ALPINE CITY COUNCIL MEETING AGENDA

NOTICE is hereby given that the CITY COUNCIL of Alpine City, Utah will hold a meeting on **Tuesday, March 10, 2015 at 7:00 pm** at Alpine City Hall, 20 North Main, Alpine, Utah as follows:

- B. **Eagle Point PRD Preliminary Plan Exceptions Review – Mark Wells and Taylor Smith – Approximately 800 W 600 N:** The City Council will make determinations on requested exceptions for the Eagle Point PRD for the final plan.

SUBJECT: Eagle Pointe PRD Preliminary Site Plan

UTAH
SLOPE ANALYSIS
EAGLE POINTE SUBDIVISION
LOCATED IN SECTION 23, T4S, R1E, SLB&M
ALPINE.

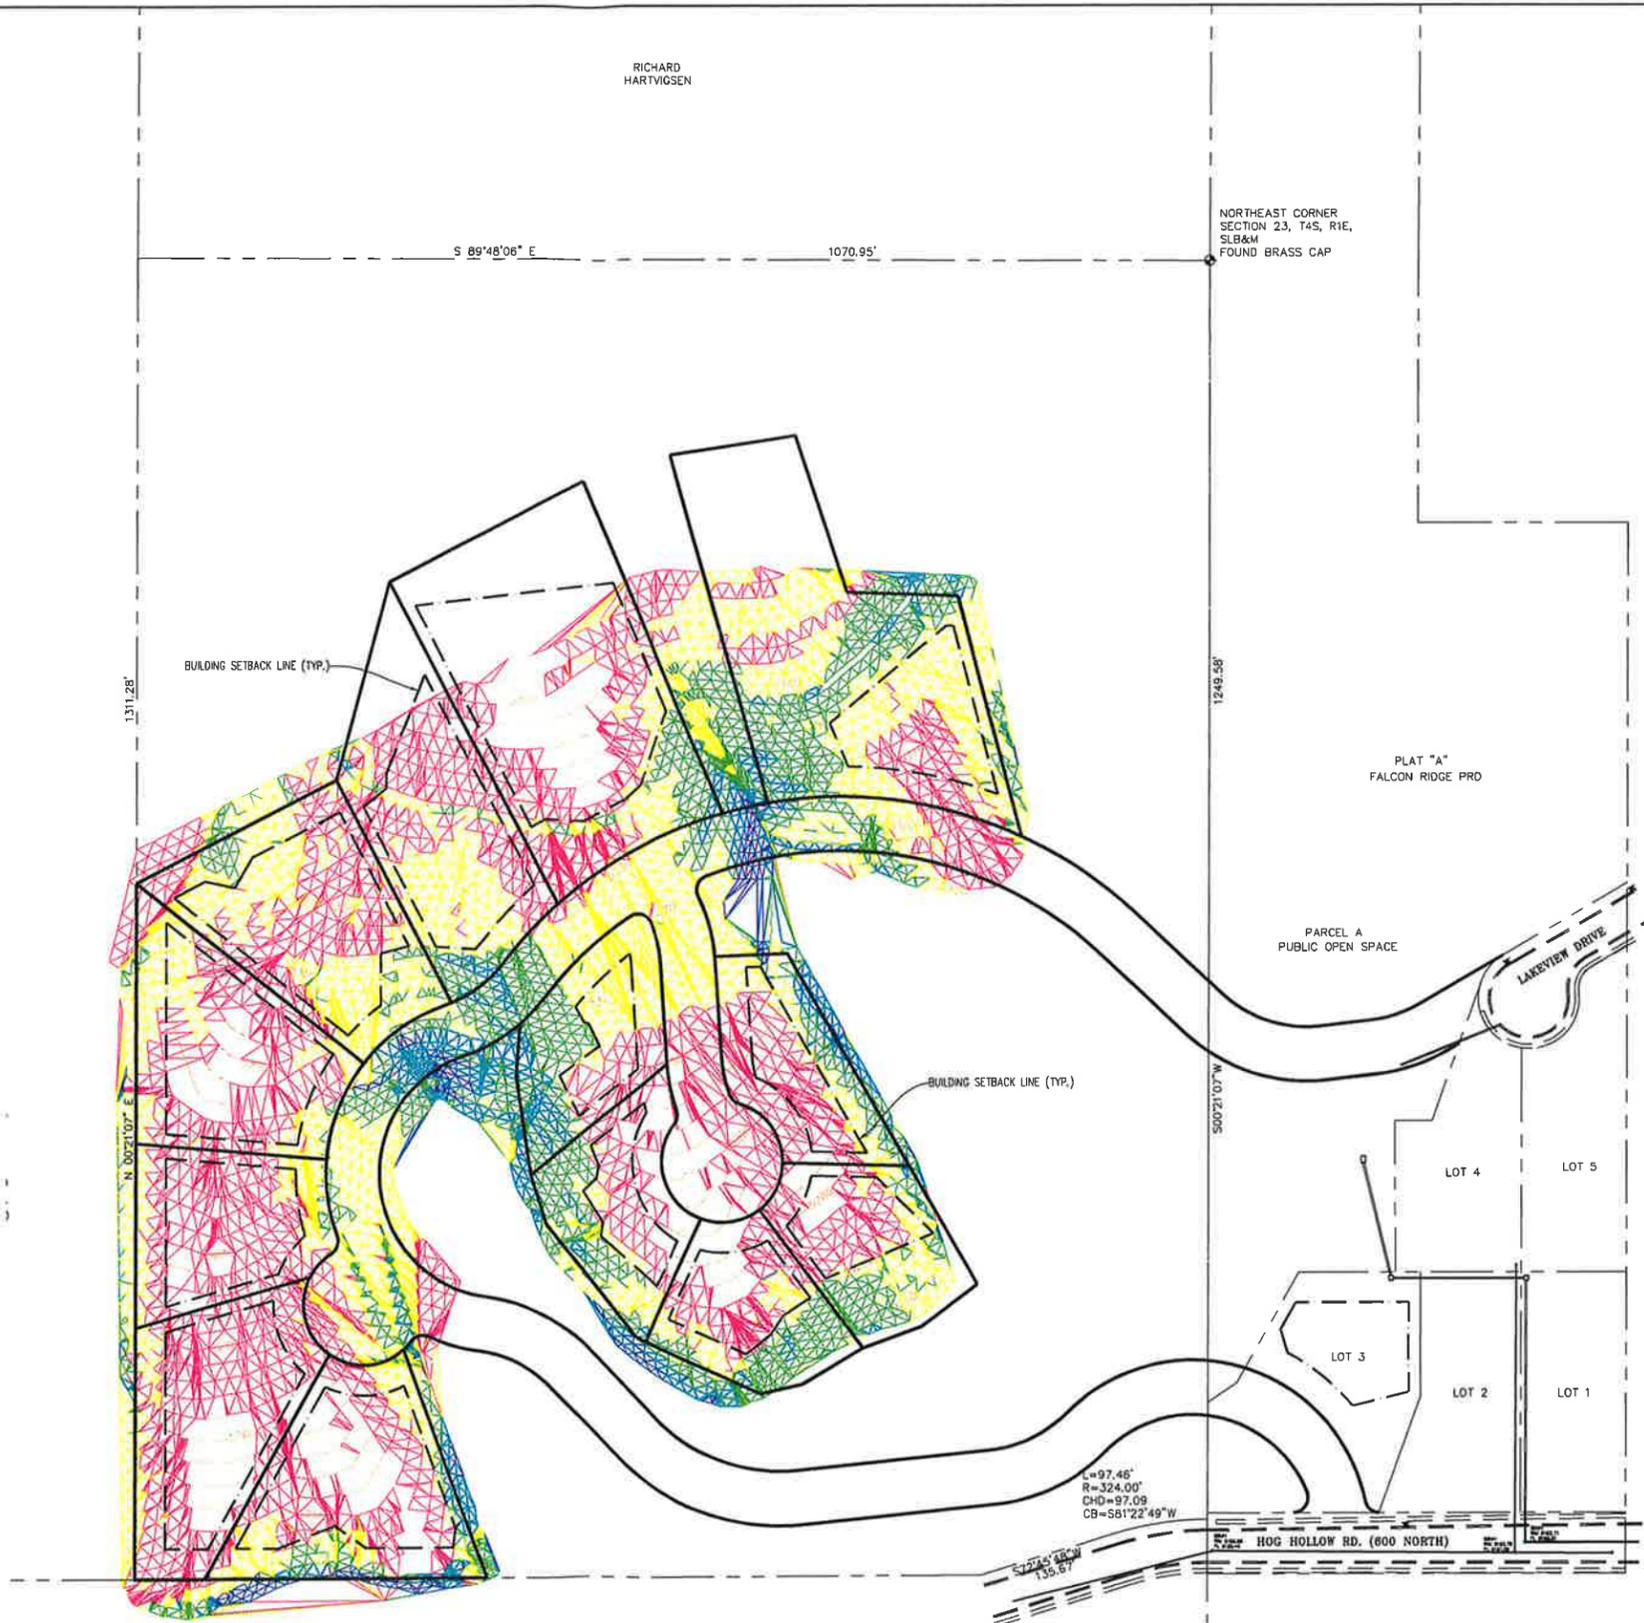
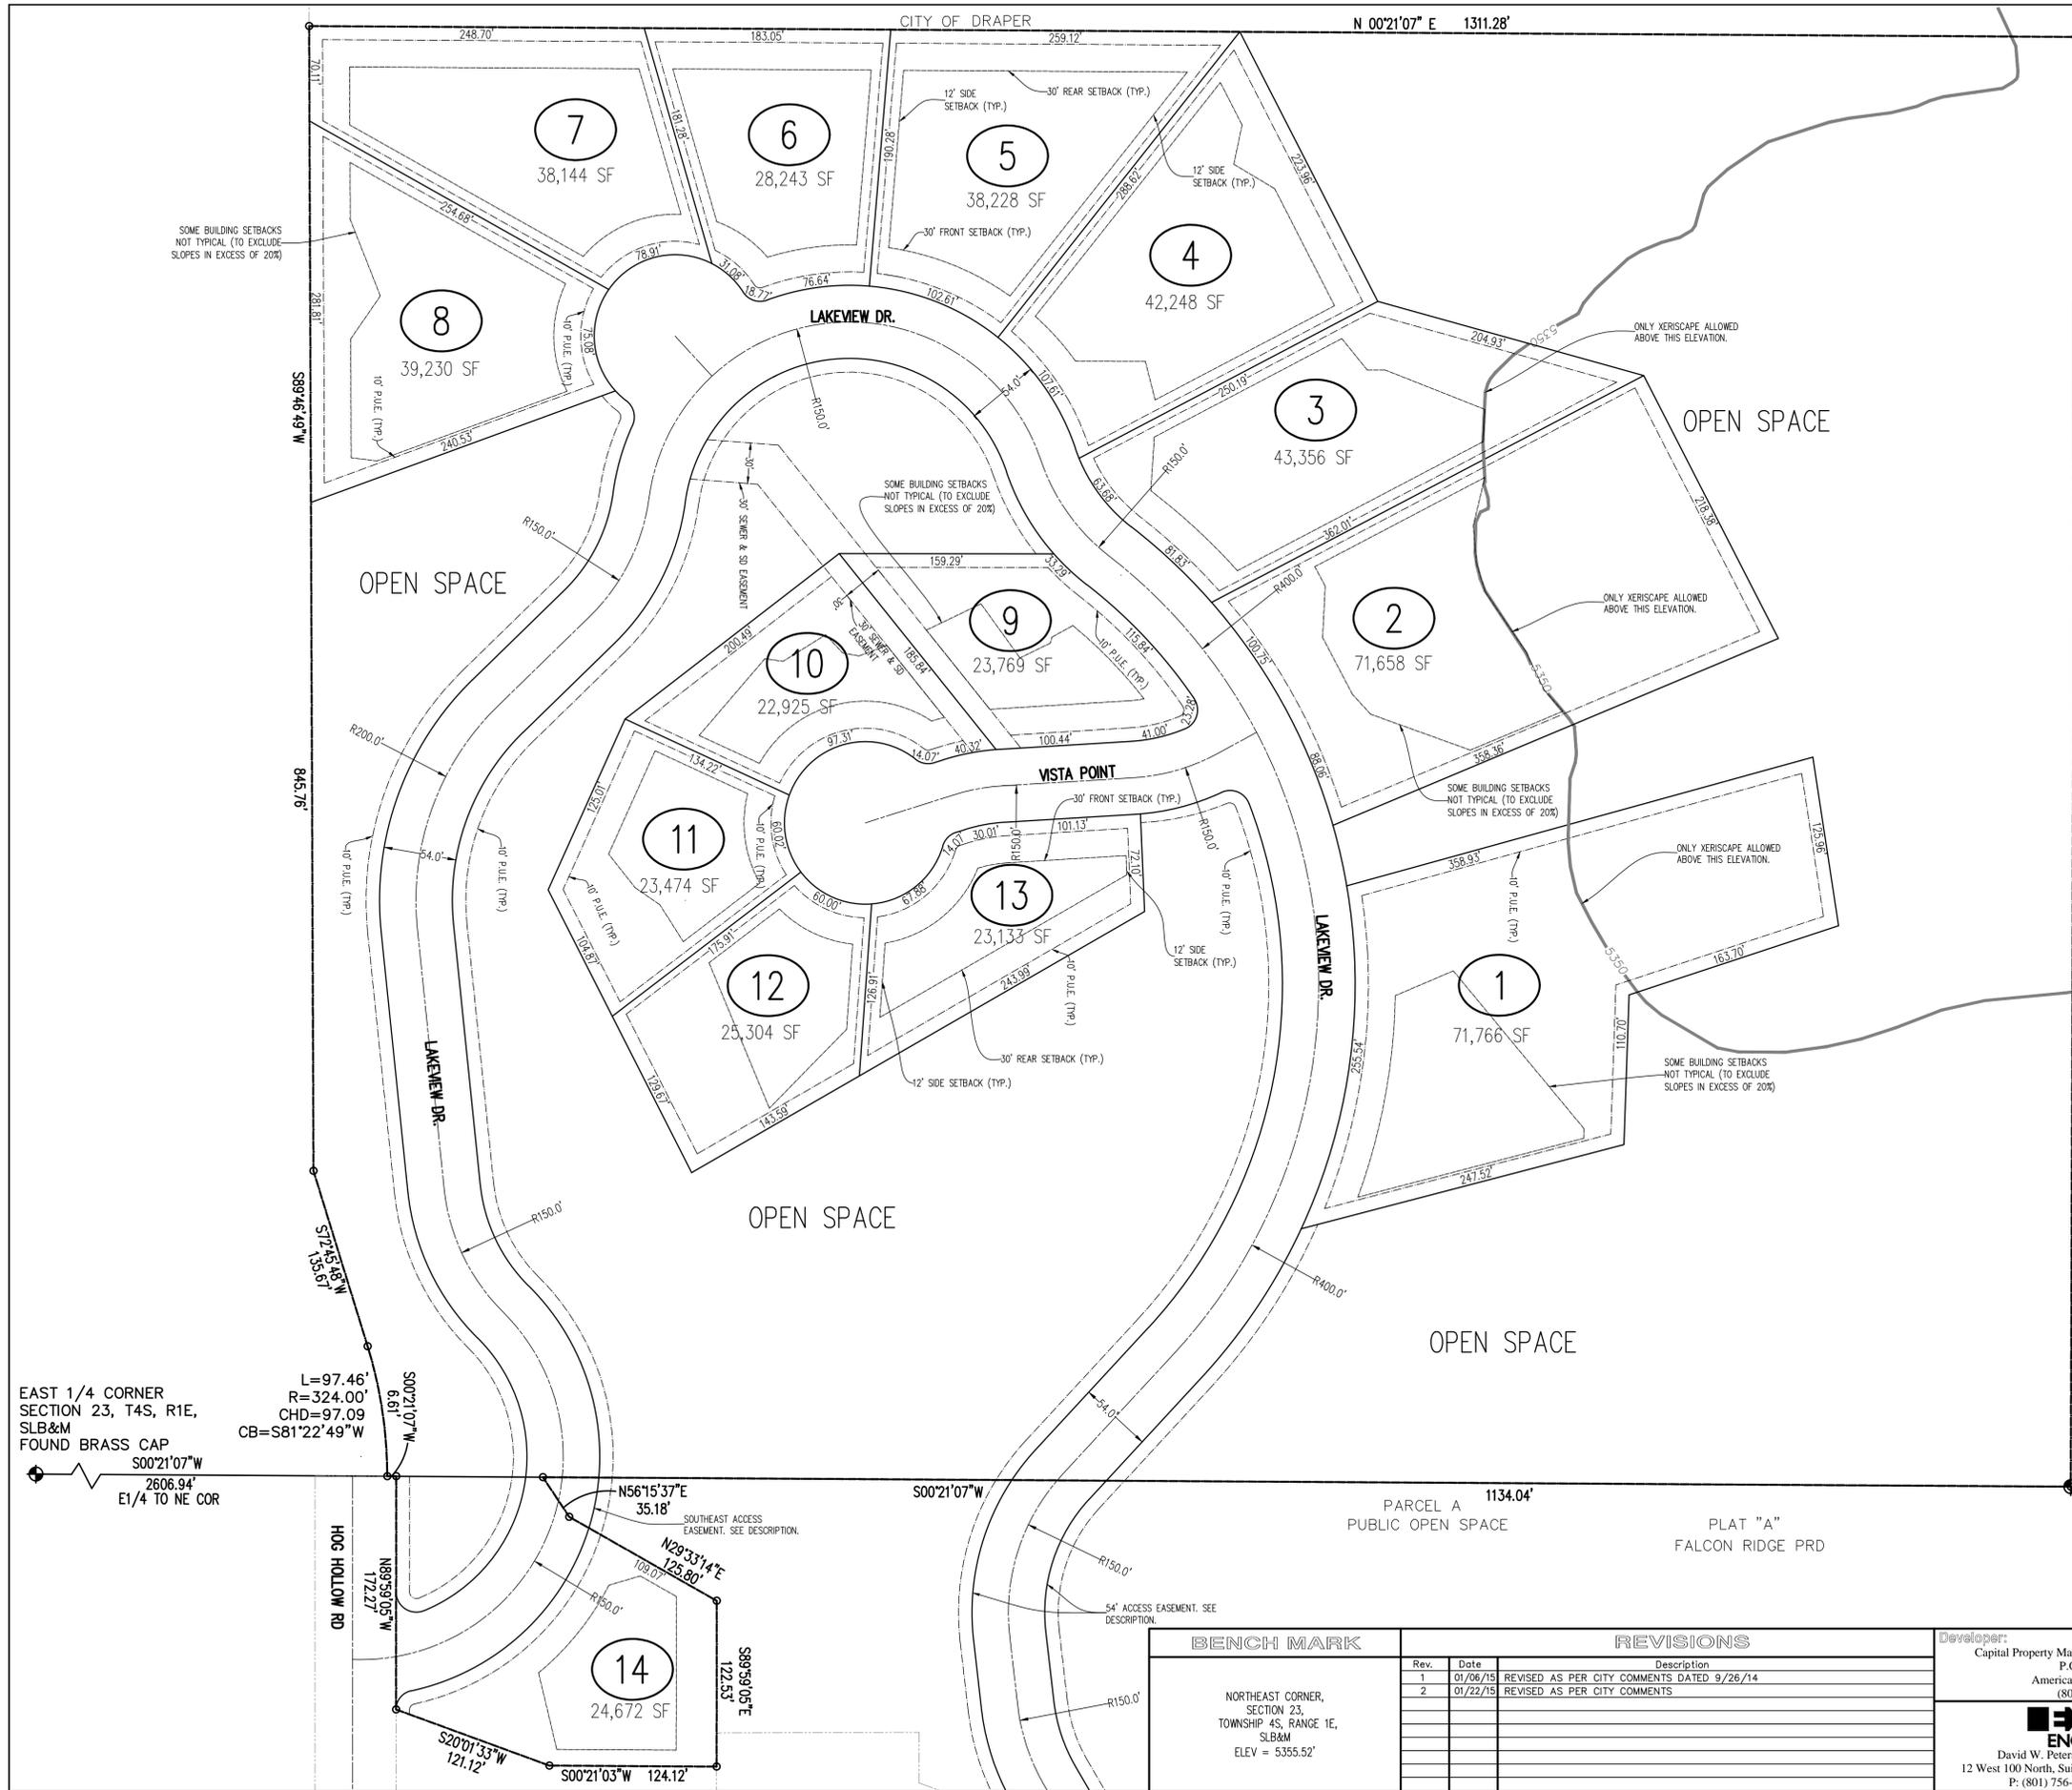
The developer did not submit a slope analysis for the property as per the PRD, however we completed our own slope analysis in 2010 and again with this submittal. Based on our analysis, we have determined that the allowable base density is 14 units. As currently drawn, the development would provide approximately 17.54 acres of open space, or 53.3 percent of the total development area. This would provide sufficient open space to receive the maximum density bonus of 25 percent. Assuming the maximum density bonus, up to 17.52 lots (rounded to 18 lots) is possible if topography allows it. Because of the topographic challenges of the area, and the Development Code which protects the city from lots being developed on a hillside, the developer has proposed a plan with only 13 new lots. As mentioned earlier, Lot 14 is an existing lot (Lot 3 Falcon Ridge Plat A) which is proposed to be amended to accommodate the secondary access required by code. This existing lot is owned by an LLC which the developer is a part of.

The slope analysis has three main purposes; (1) is used to calculate base density, (2) helps evaluate building pads and (3) shows the percentage of land with slopes greater than 25% within a lot. The Developer has shown the building pads on the proposed Preliminary Plat. The pads appear to meet section 3.1.11.7 which requires no areas of ground greater than 20% slope to be within the buildable area. Section 3.9.4 details how much slope above 25% can be contained within a lot. All the new lots contain ground that is steeper than 25%. **The proposed plan will require an exception be recommended by the Planning Commission and approved by the City Council for this slope as outlined in section 3.9.4 of the Development Code.**

- **The Planning Commission recommends and City Council approves the following:**
 - **an exception for the small amounts of property within the lots that contain land sloped greater than 25% (Section 3.9.4)**

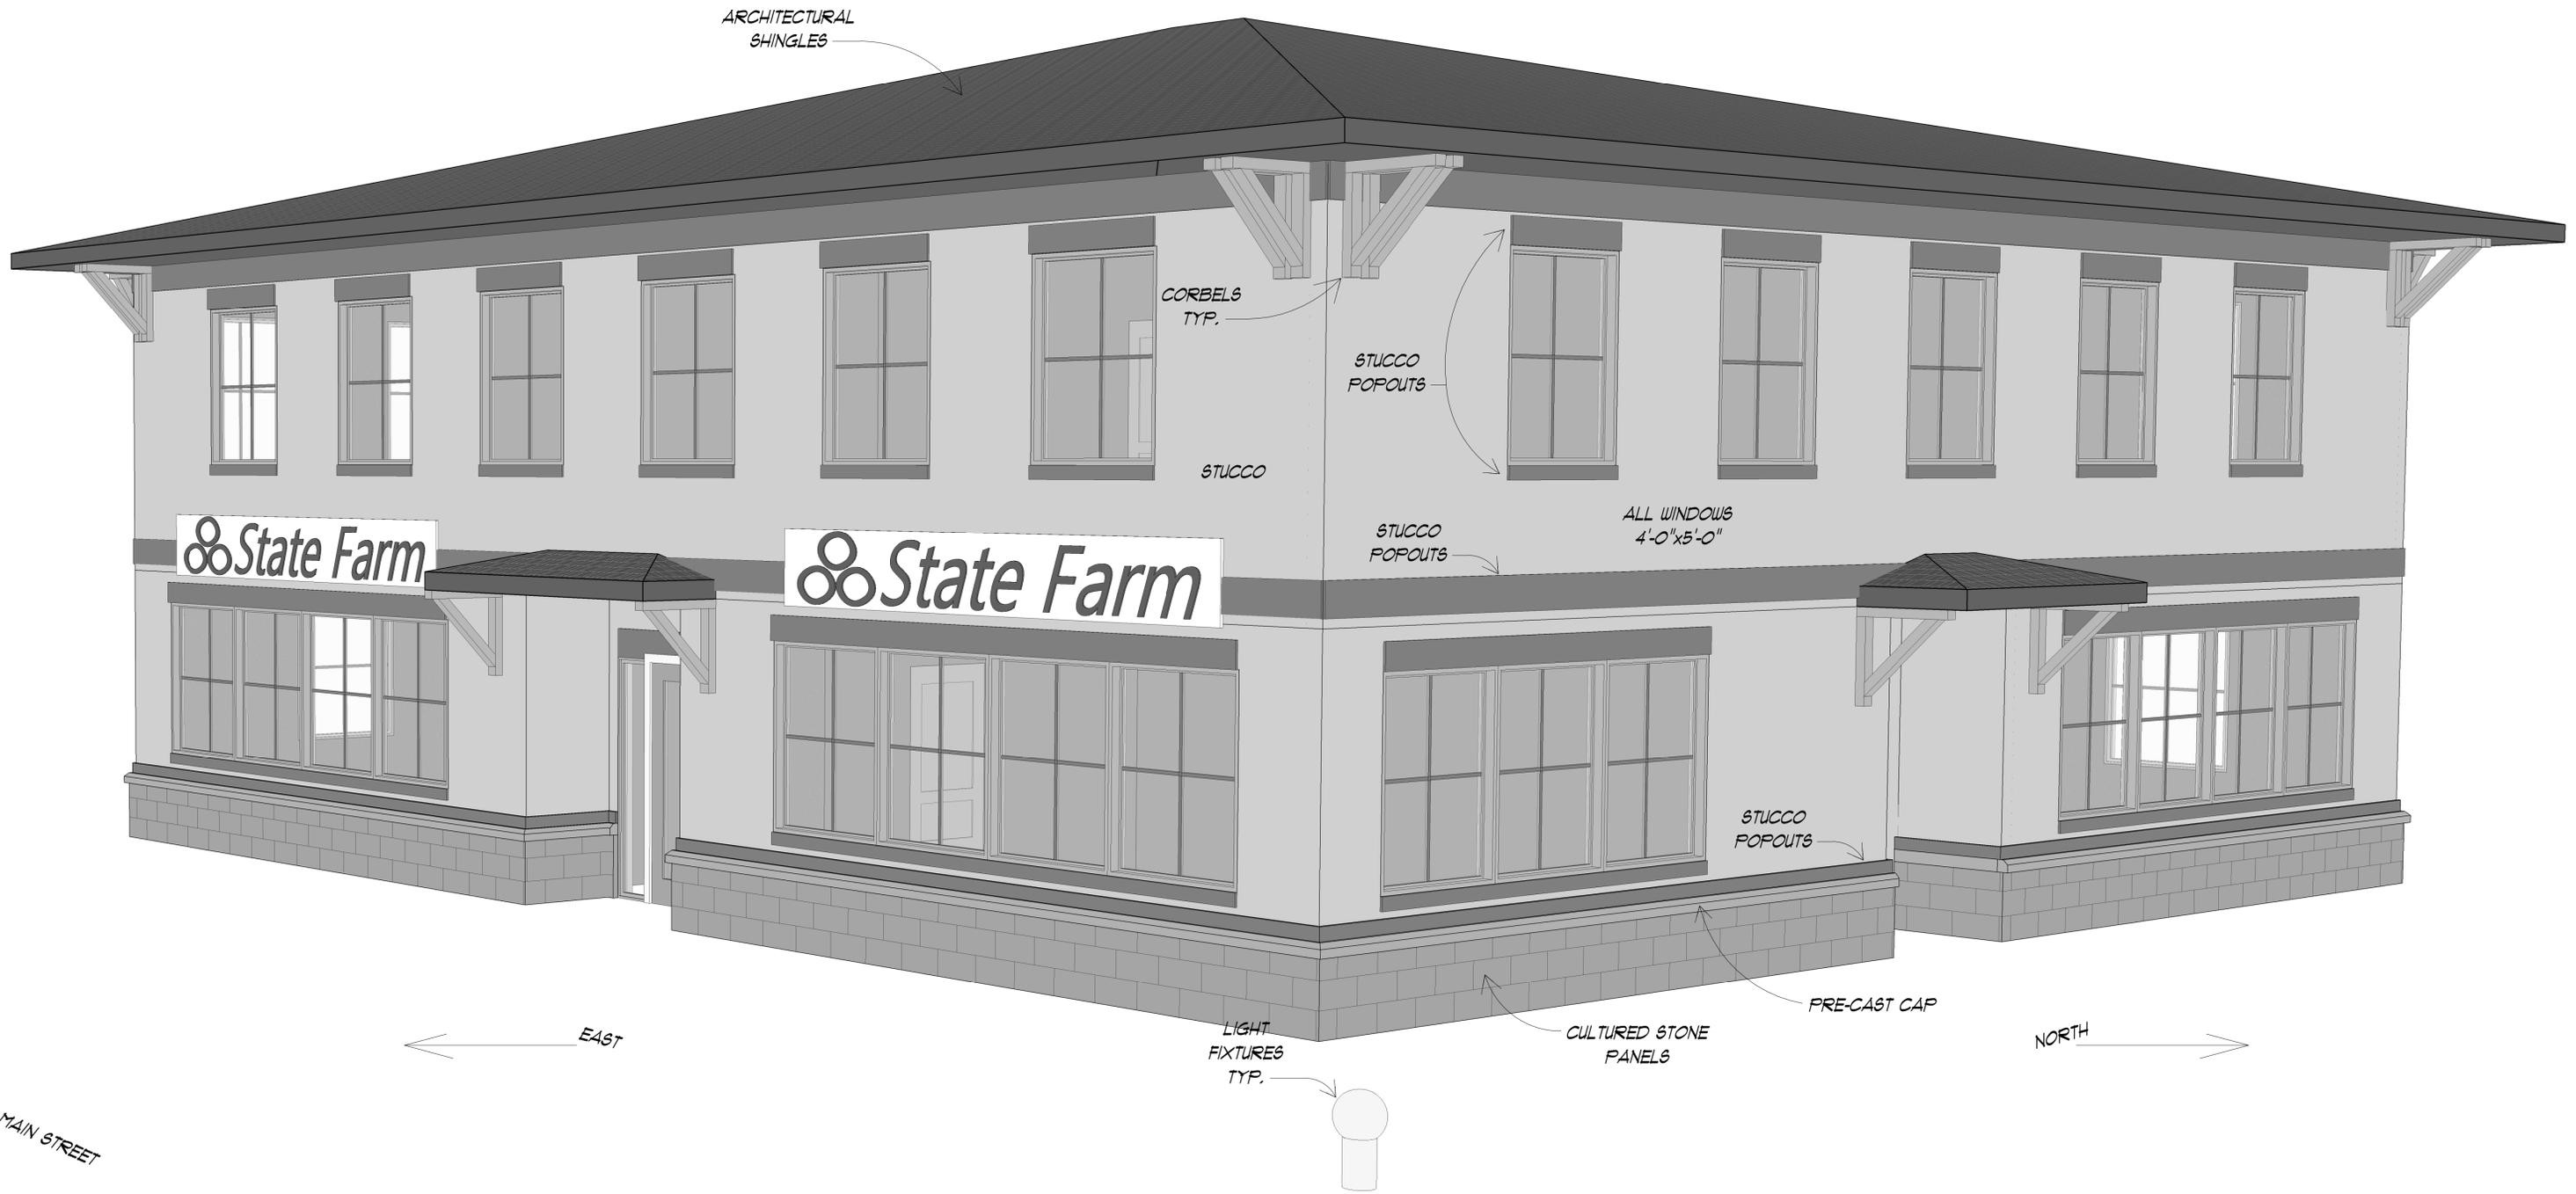
There is an existing power pole on the southern edge of the proposed parking that is shown to be relocated.

There are some minor redlines on the plan to be corrected
